PORTLAND MAINE

Project Name: **409 Cumberland Apartments** Project ID: 2013-148
Address: 409 Cumberland Avenue CBL: 036 H018001, H019001
Applicant: Avesta Housing, Avesta 409 Cumberland, LP
Planner: Caitlin Cameron

PLANNING BOARD REPORT PORTLAND, MAINE

409 Cumberland Apartments
409 Cumberland Avenue
Level III Site Plan/Subdivision
Project ID #: 2013-148
Avesta Housing, Applicant

Figure 1 - Site Plan

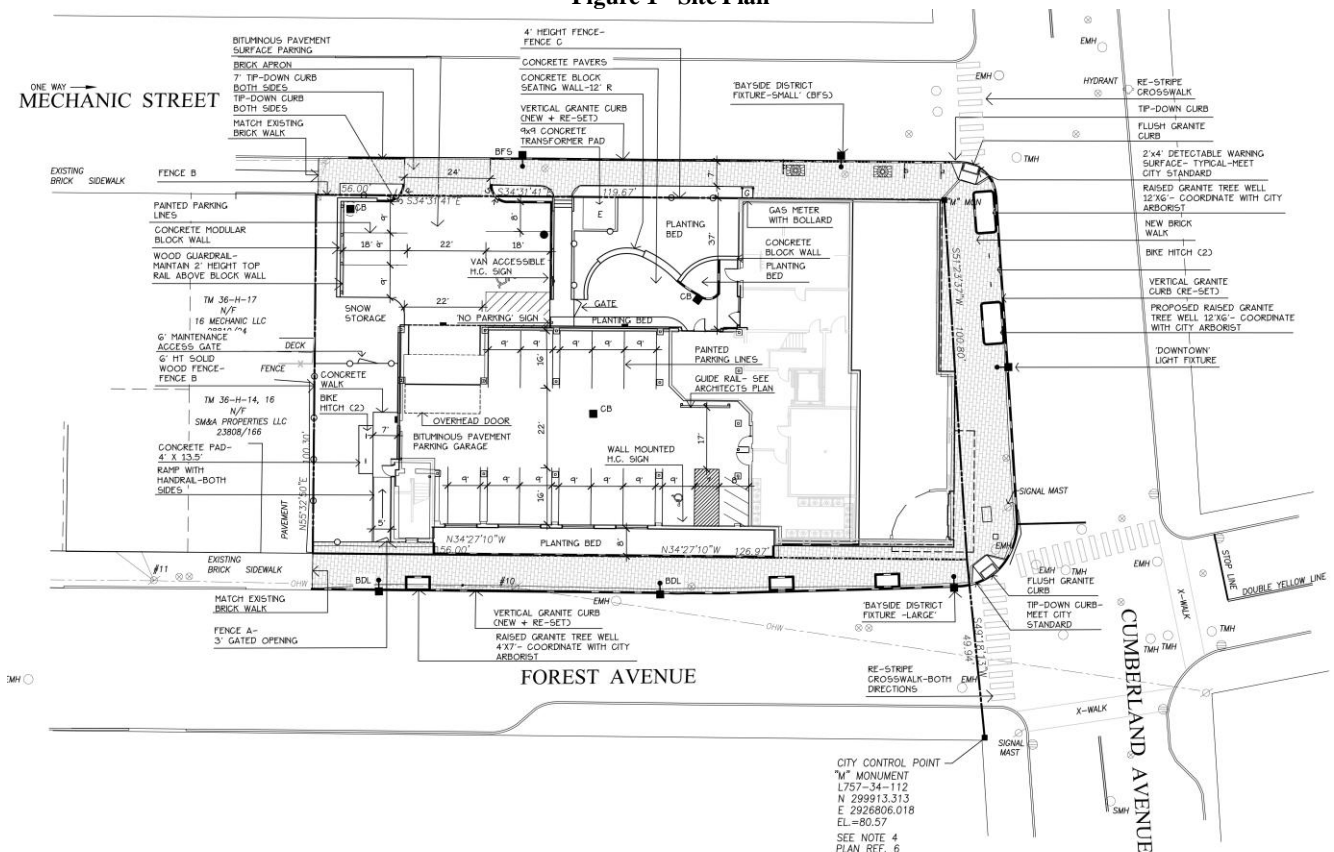
The proposal includes twenty-five (25) parking spaces including twelve (12) indoor spaces for cars (1 ADA accessible space), six (6) surface spaces, and additional motor scooter parking (3 spaces), and a bicycle storage room (28 spaces). The applicant proposes to use one (1) on-site parking space as a carshare space which under the zoning ordinance accounts for eight (8) parking spaces. The on-peninsula zoning requirement is one (1) parking space per unit. Alternative designs to increase the parking on-site were considered but deemed infeasible due to the sloped site. However, for projects with over 50,000 sf the Planning Board determines the required number of spaces based on a traffic report.

Figure 2 – Zoning/Building Setback Waiver Diagram

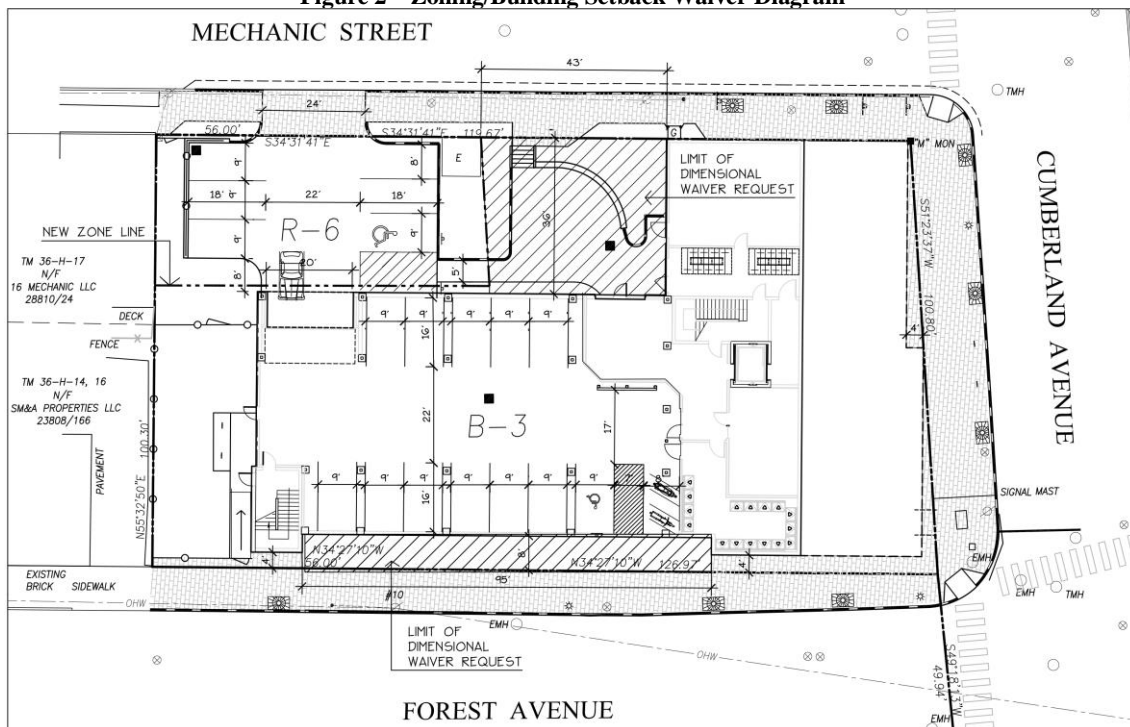
The applicant requested partial relief from Section 14-220 Dimensional Requirements (c) Street Wall Build-to Line. The proposed building does not meet the five (5) foot maximum setback requirement for street frontages in two locations. On Mechanic Street, the building is setback at thirty-six (36) feet for a length of forty-three (43) feet to accommodate a resident-accessible open space. Although typically a waiver request for this condition would require the open space provide substantial and viable publicly accessible open space that reinforces and supports pedestrian activity and interest, in this case, there is substantial concern from the neighbors, applicant, and Planning Board about the security of that space. Under these circumstances the applicant has reviewed with staff a revised design that will maintain visibility from the public right of way, but will be physically accessible only to residents (Attachment Plan 2). In the second area of the project requesting a waiver on Forest Avenue, the building is setback eight (8) feet for a length of ninety-five (95) feet. The Forest Avenue waiver does provide publicly accessible street level amenity. The area that is setback eight (8) feet is providing variability to the façade which is otherwise lacking in street vitality without storefront or building entrances. The setback does not substantially detract from the prevailing street wall character nor does it detract from existing open space. The area of setback is Southwest-facing which allows for acceptable orientation for solar access to be attractive to pedestrian activity. The quality and character of design has been reviewed with staff and will include trees and curbing. Staff suggested additional amenities such as seating wall and a green wall which the applicant was not able to accommodate in this location.
